ORIGINATION FORM

Proposed Revisions to a Standard Plans Index
(Please provide all information — Incomplete forms will be returned)

Index Number: 521-611

Index Title: Concrete Barrier/Junction Slab - Wall Coping

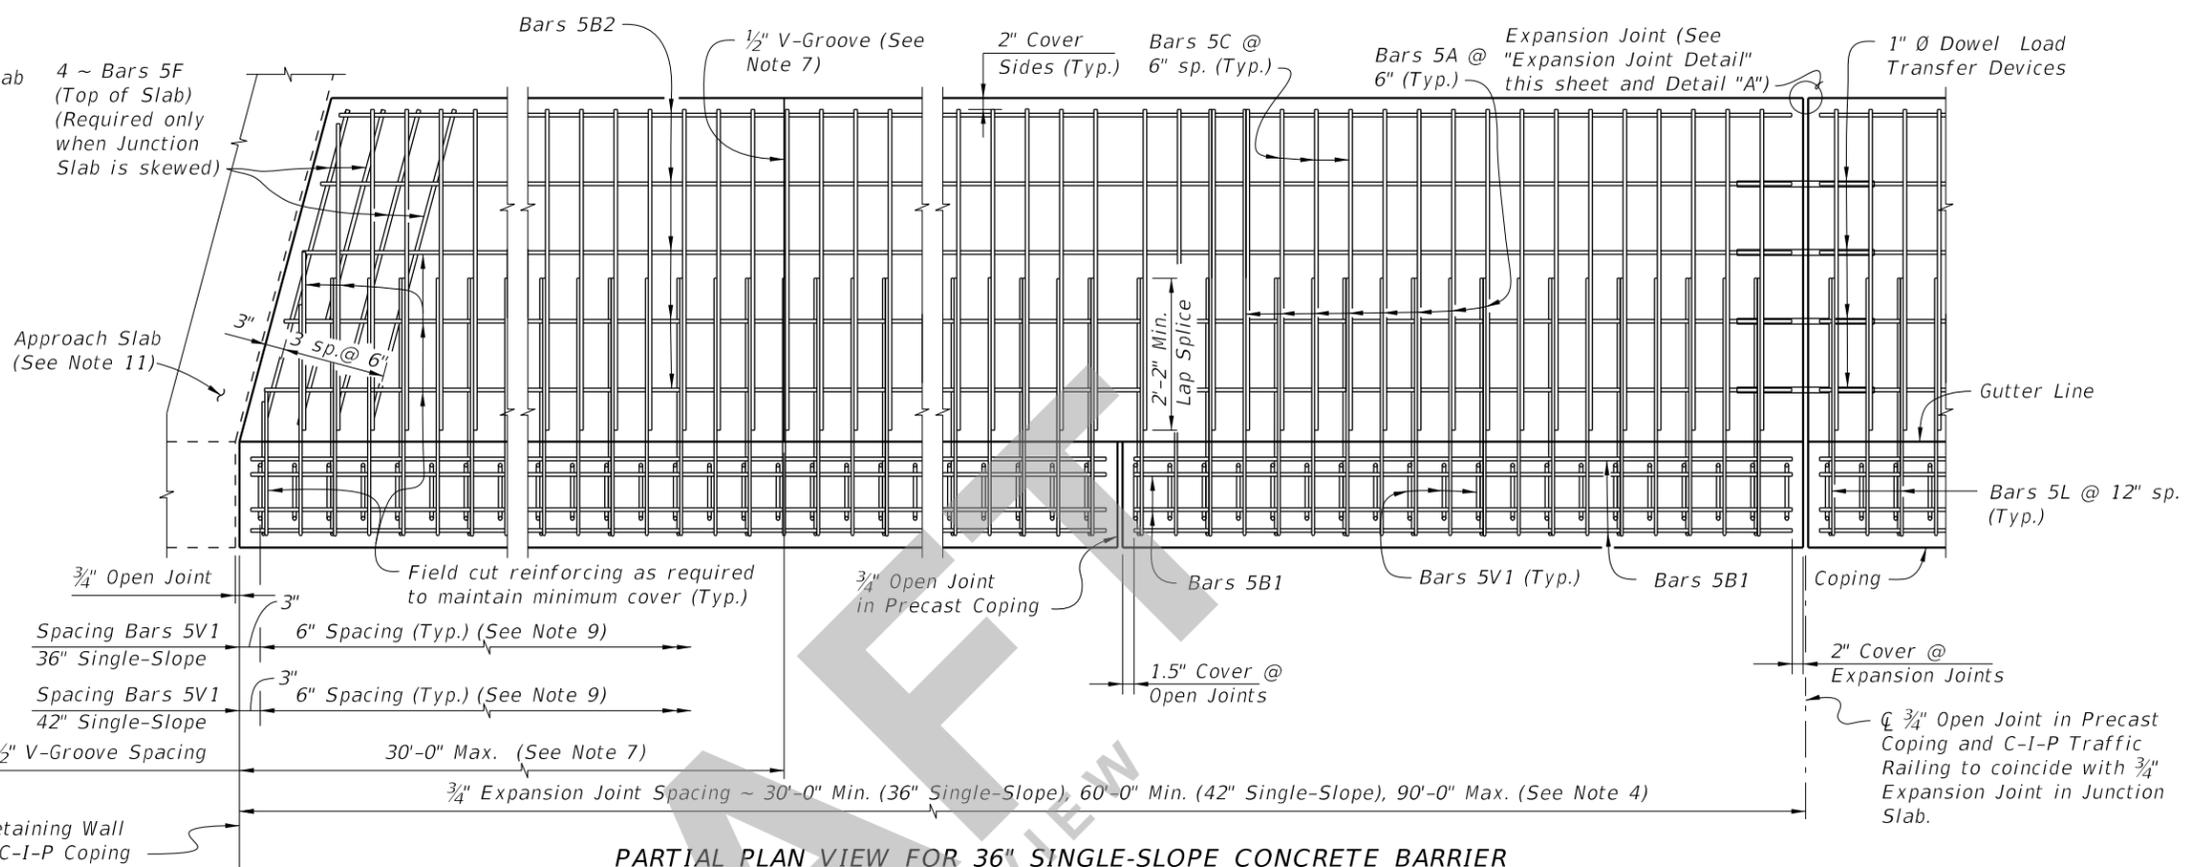
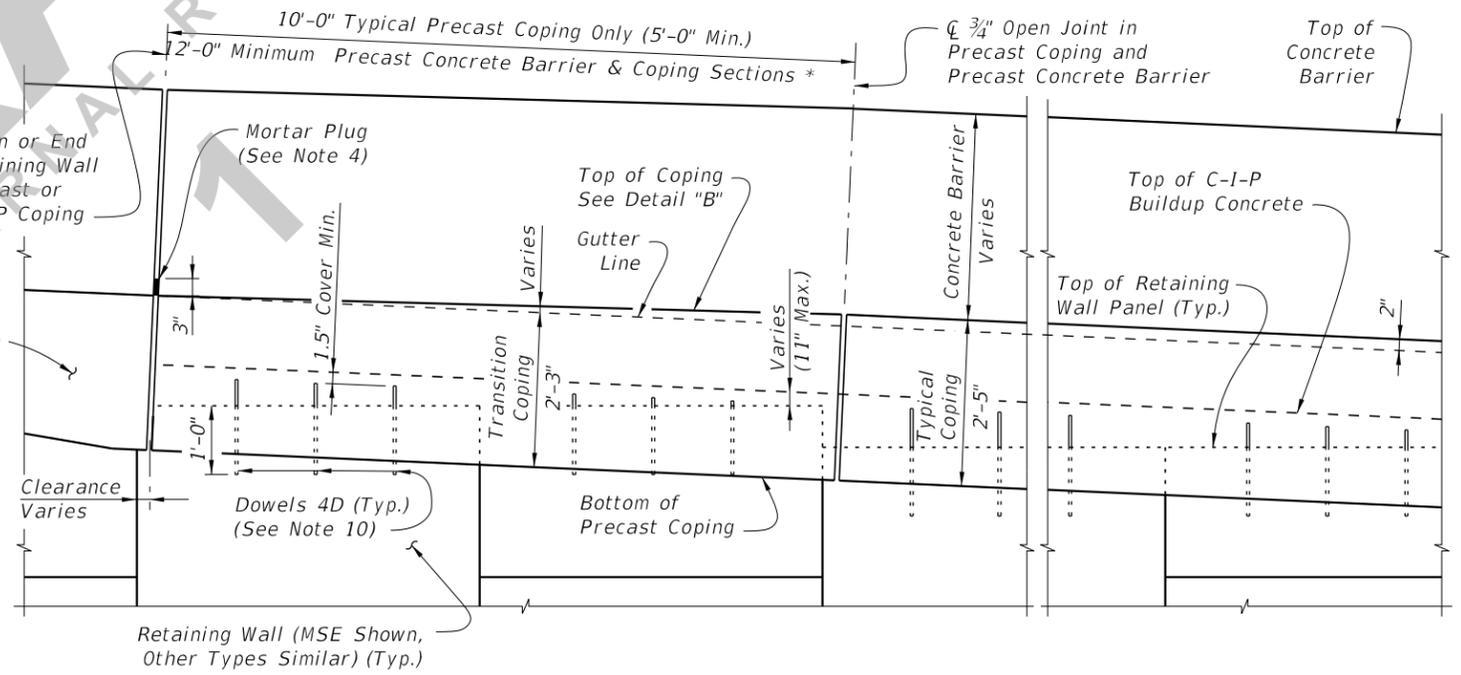
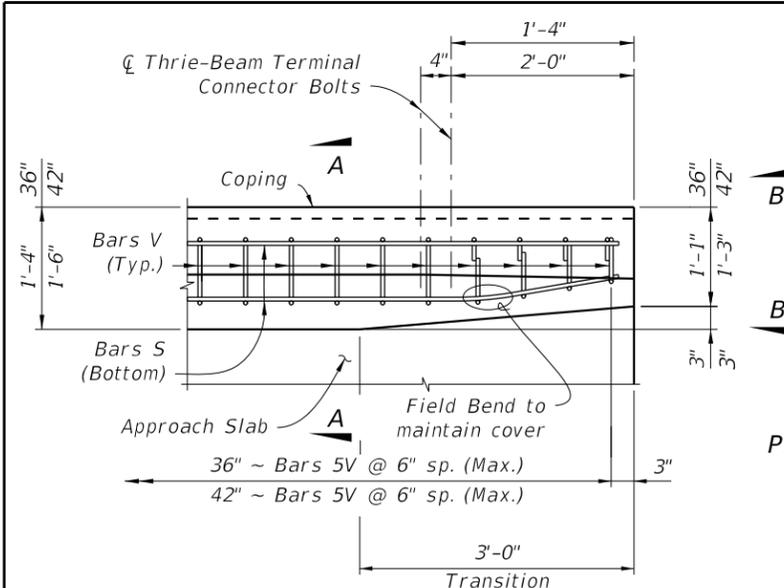
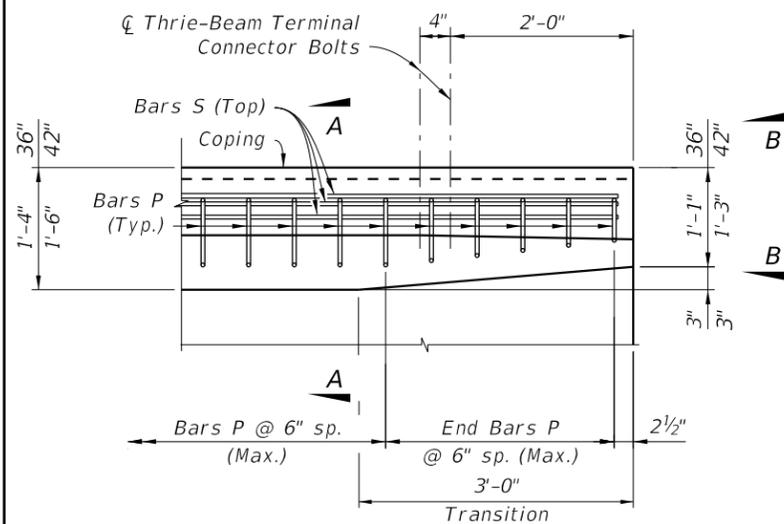
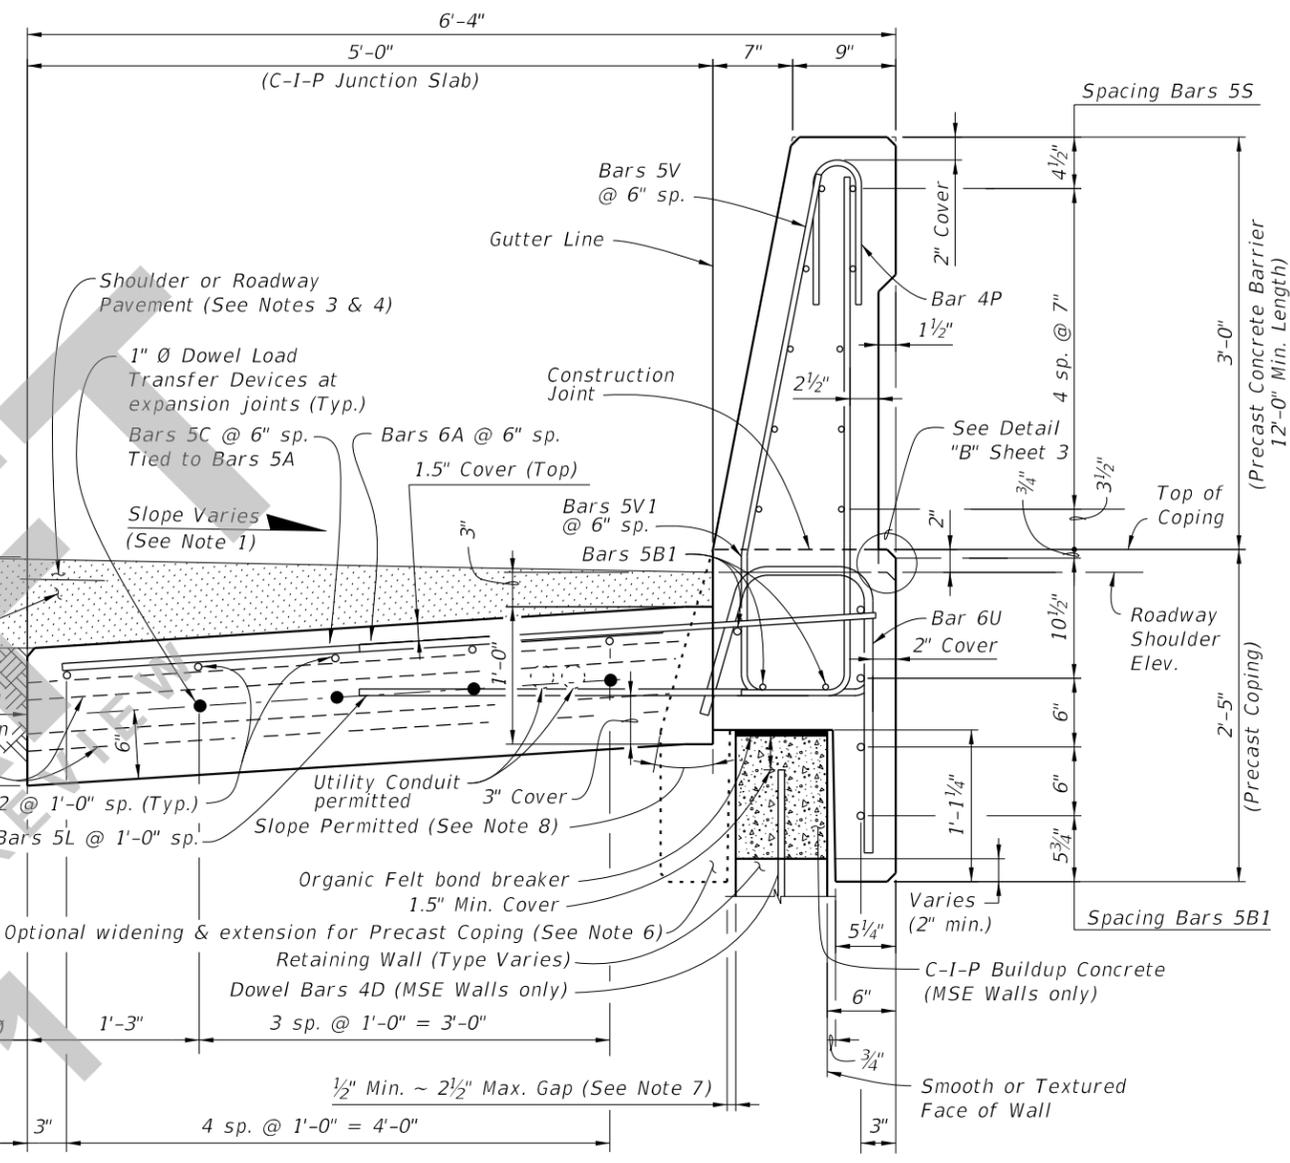
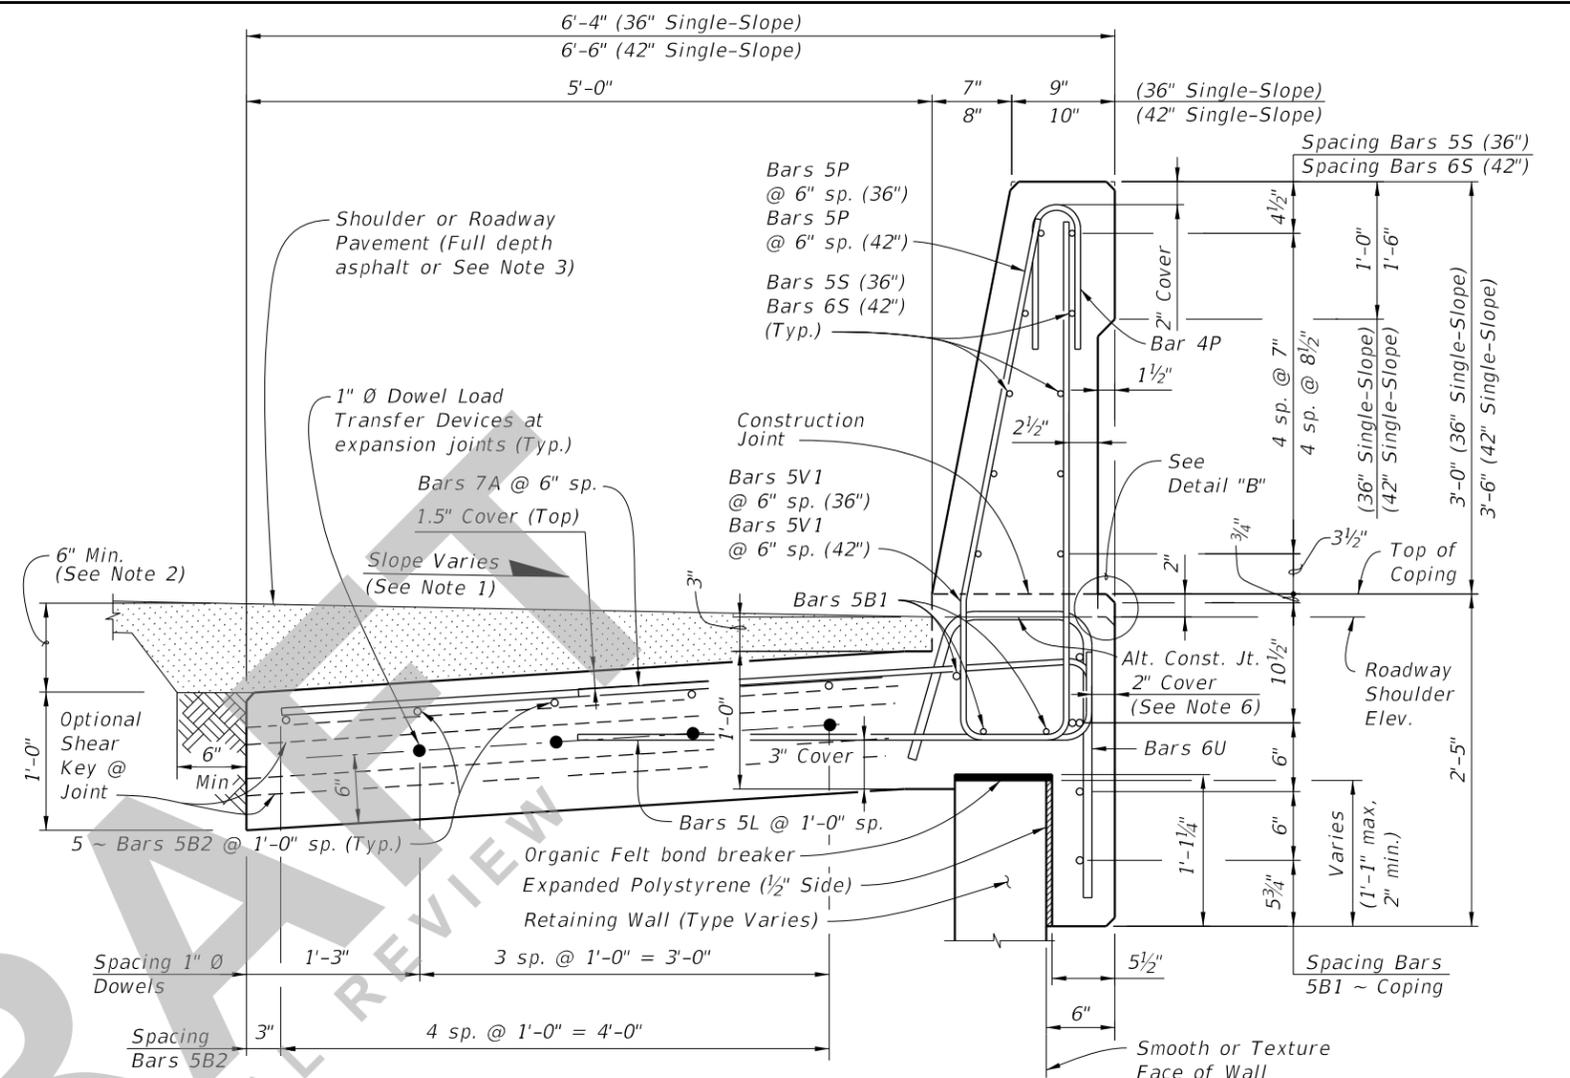
NEW Index

Added for use when non conductive reinforcing is required near tolling facilities or for extremely aggressive conditions (when required in the plans)
